**CHESAPEAKE BAY TMDL PROJECT
(4 PONDS)
IFB No. 15304-FY17-15
Addendum #3
November 10, 2016**

CHESAPEAKE BAY TMDL PROJECT
 PHASE 1
 GREENWAY POND RETROFIT
 100% CONSTRUCTION DOCUMENT

CHESAPEAKE BAY TMDL PROJECT
PHASE 1
KOHL'S POND RETROFIT
 100% CONSTRUCTION DOCUMENT
 TOWN OF LEESBURG, VIRGINIA
 CATOCHTIN ELECTION DISTRICT

TEST PITS # 1, 2 & 3

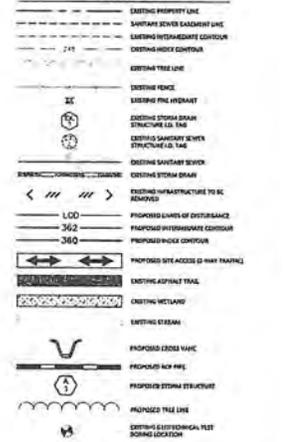
TP #1: ROCK REFUSAL @ 5.5' DEEP.
 T.P.#2: ROCK REFUSAL @ 3' DEEP.
 T.P.#3: NO ROCK AT 8' DEEP.

DESIGN BY: MB/JGR DRAWN BY: MEG
 REVIEWED BY: MB/JGR
 PROJECT MANAGER: TB
 AMEC FOSTER WHEELER PROJECT #: 565500011
 CONTRACT #: 300810-FY12-03
 DATE: 2015-08-18 SHEET SIZE: D
 SCALE: AS SHOWN
 SHEET TITLE:
TREE REMOVAL GUIDANCE

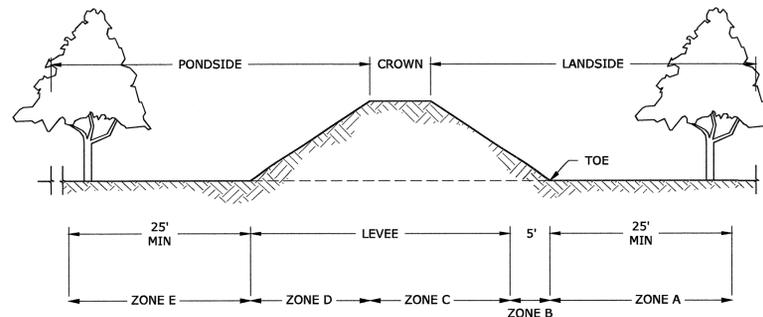
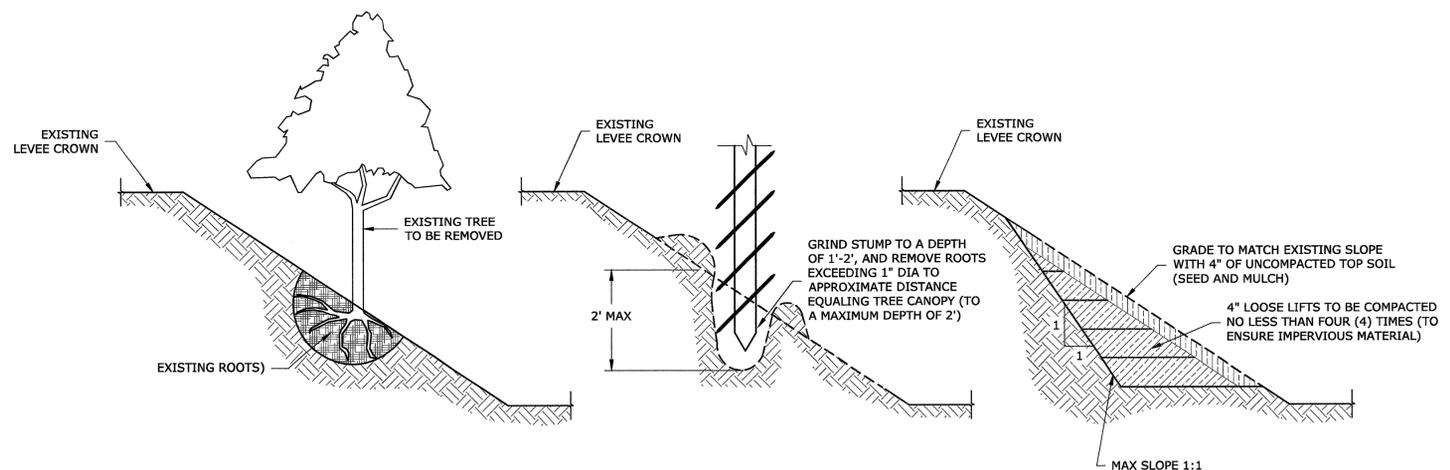
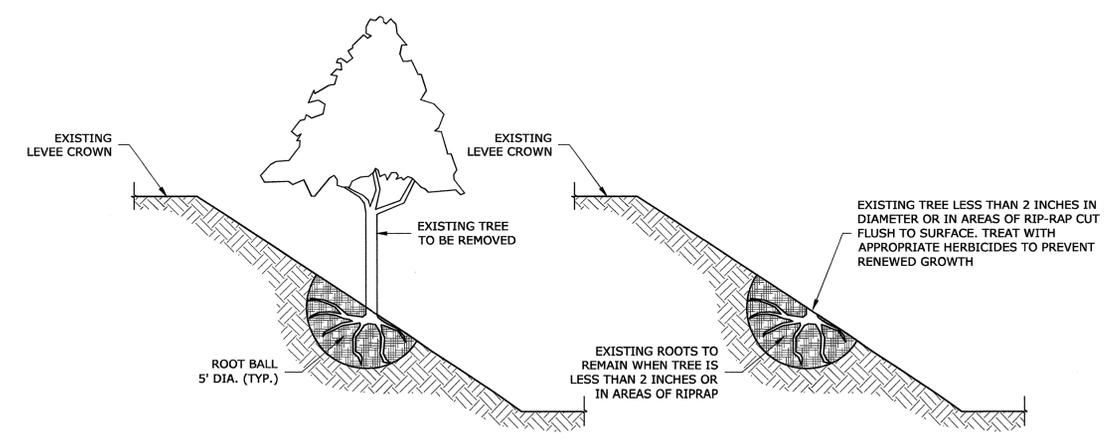
- 1. This is a Lump Sum Contract; the Contractor is responsible for estimating the required rock excavation quantity, and shall carry out all required rock excavation including disposal at no additional cost to the Town. The stipulated rock unit price on page 7 of Instructions to Bidders will be used in the case of additional work beyond the scope of the base contract.**
- 2. Attachment 'A' - Greenway Pond Test Pits**
- 3. Attachment 'B' - Revision to sheet 20 of 28 "Greenway Pond Retrofit".**
- 4. Attachment 'C' - Revision to sheet 21 of 21 "Kohl's Pond Retrofit".**
